This page lists the know errors on the gm5x5x5 PCBs. There are no known issues with the bulk order run (white pcbs), the following information is valid **only** for the prototype run (green pcbs).

## **Bulk Order #1 (white pcb, rev 1.0)**

# **Prototype Run (green PCBs)**

## #1 MIDI IO pins

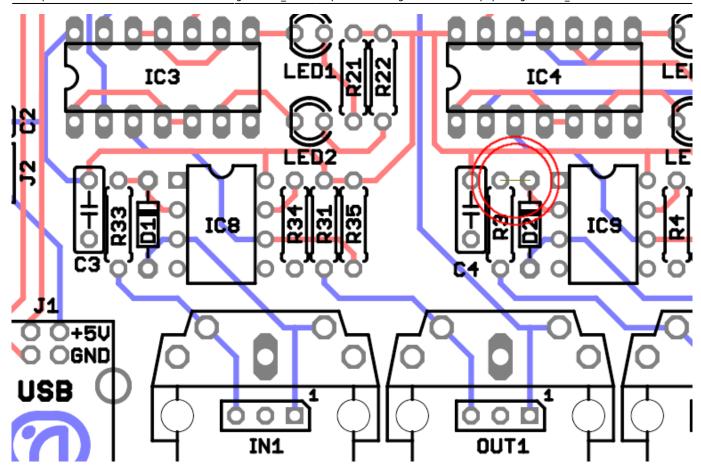
**Problem**: The MIDI IO pins of the midi sockets (Pin 4 + 5) are switched.

**Solution**: Either (1) use the pin-headers if you use sockets that are not mounted on the pcb or (2) break the traces to pins 4 + 5 of the sockets and solder wires to them or (3) solder the midi sockets on the other side of the pcb.
